NOTICE TO CONTRACTORS

BID #1415-189

Mountain Street Utility Rehabilitation Project

Addendum No. 2

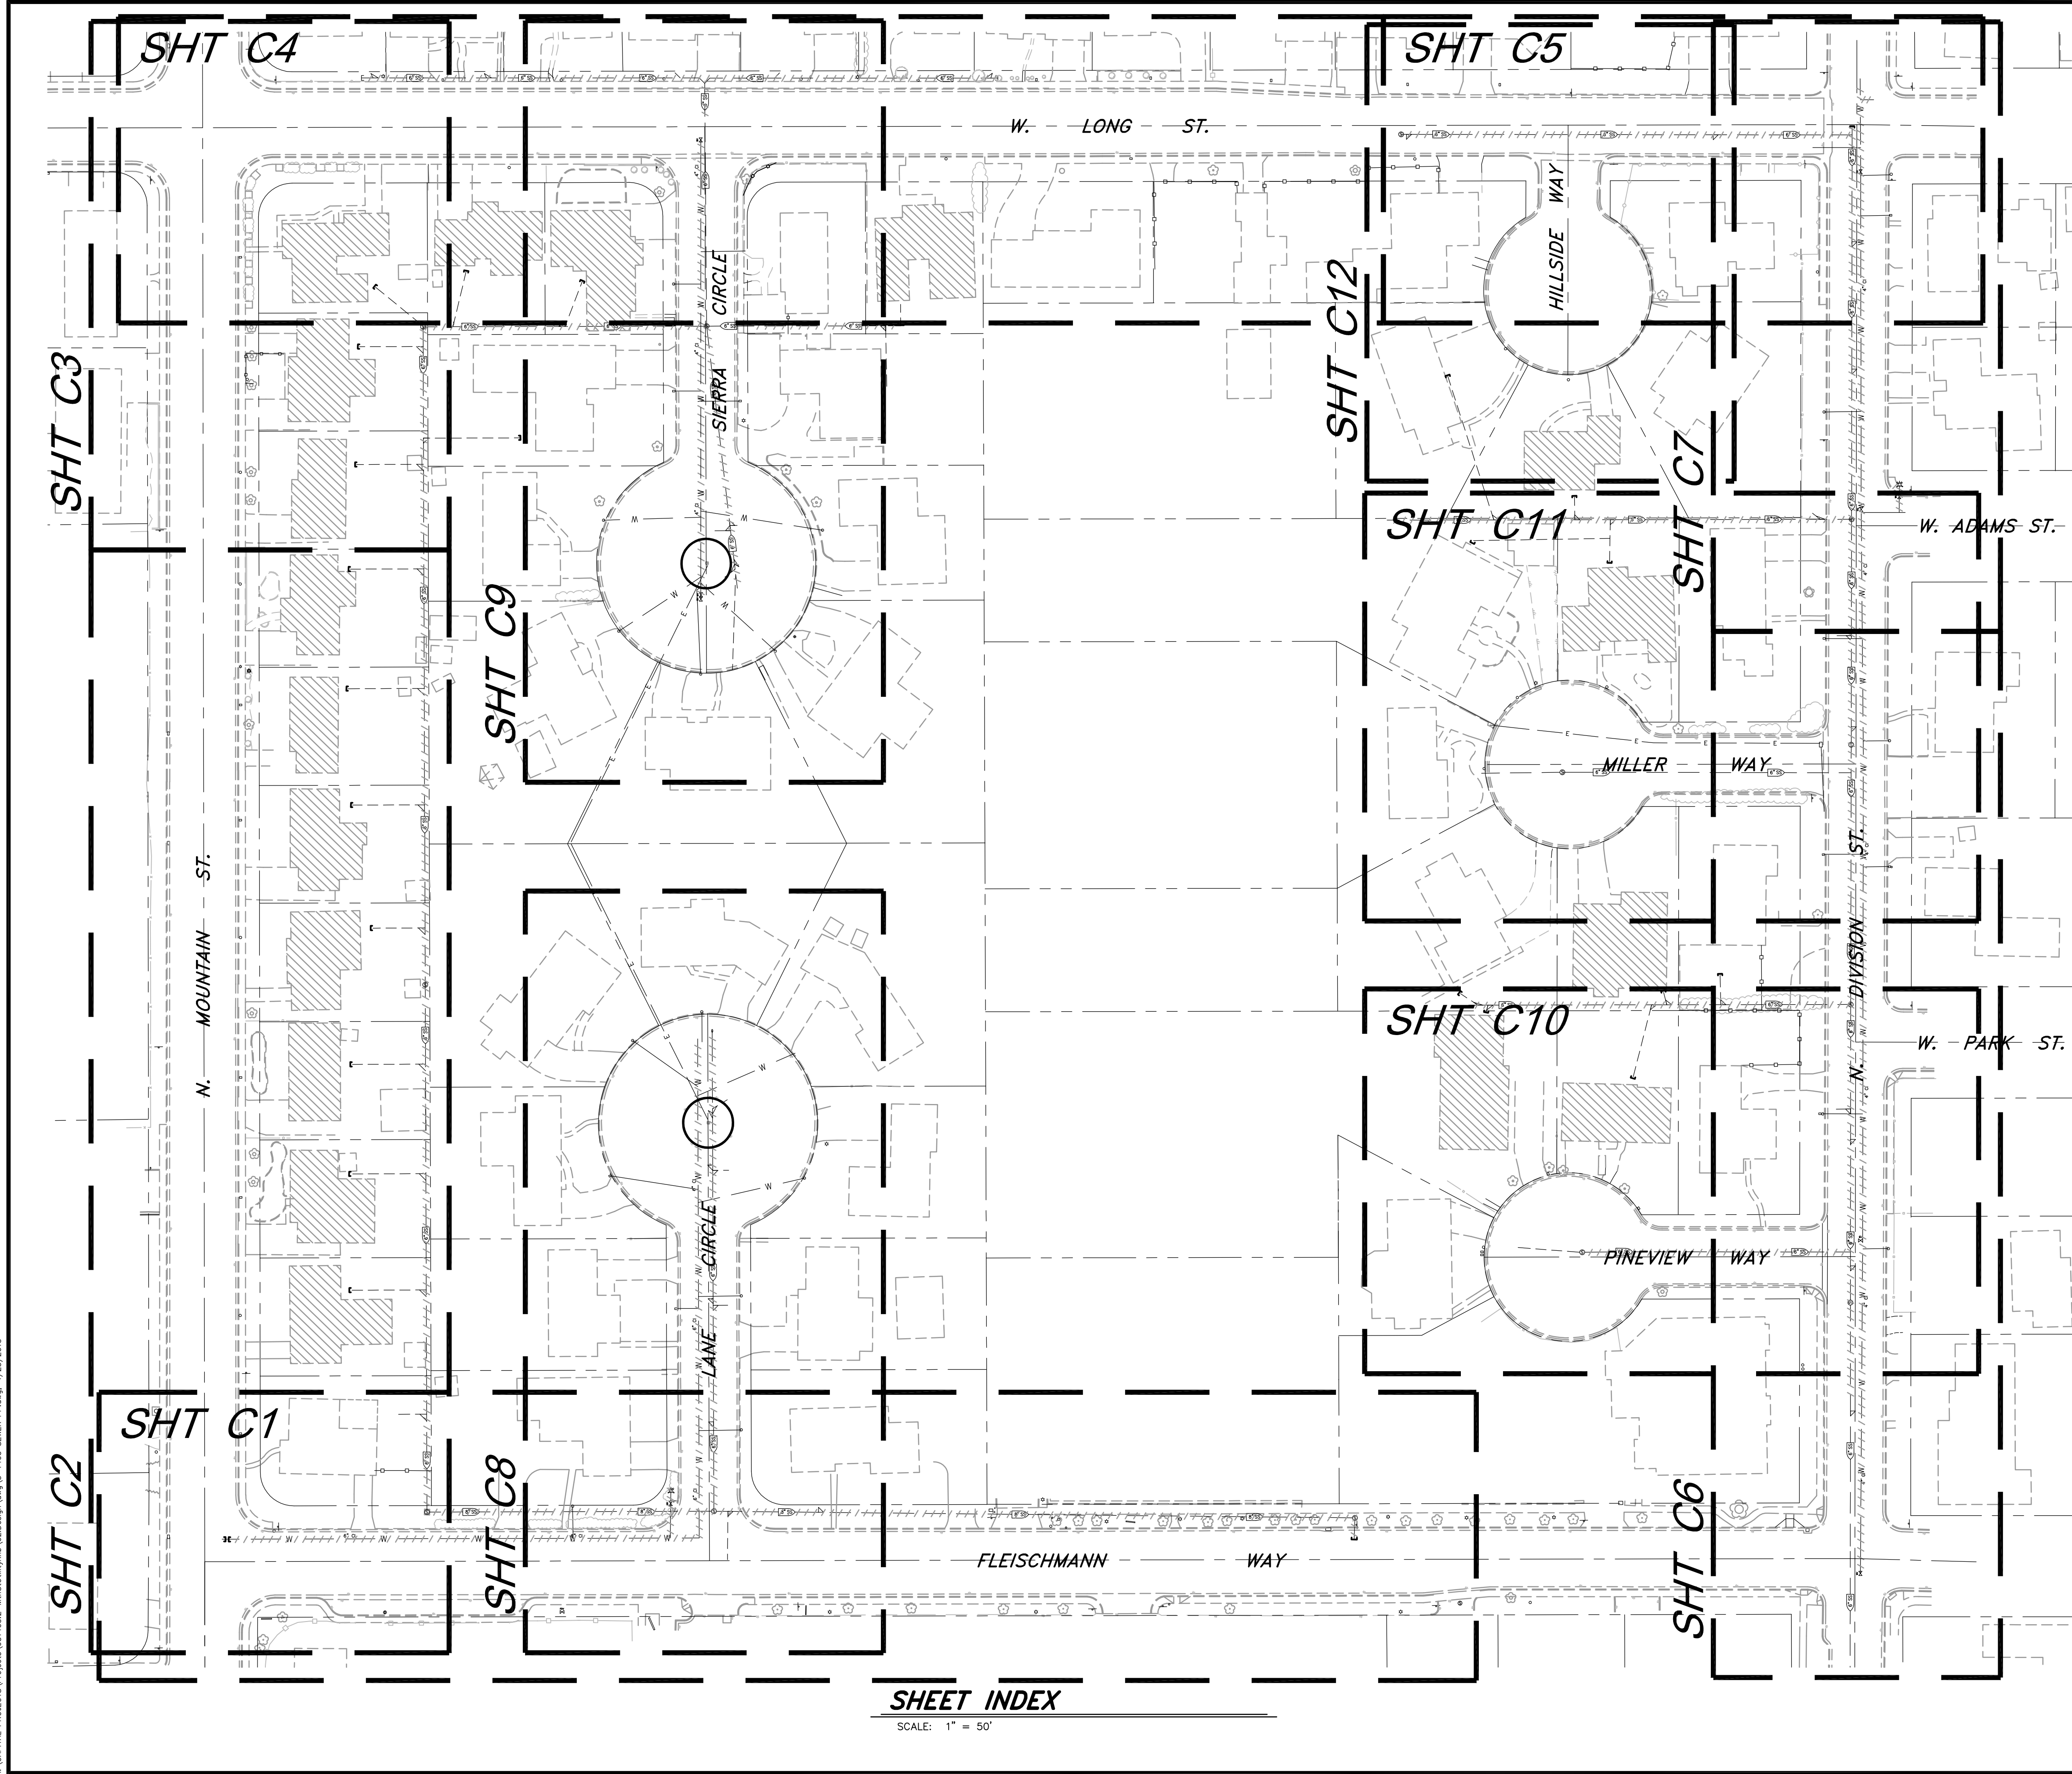
1. 3 Sierra Circle is listed in the Special Conditions as plumbing work on site but not within the building. See page SC-11. Plan sheet C9 shows the building as hatched (needs reverse plumbing) Please advise.

3 Sierra Circle doesn't need to be re-plumbed. Revised sheets are attached showing the correct routing for the sewer lateral and removal of the hatching on 3 Sierra Circle.
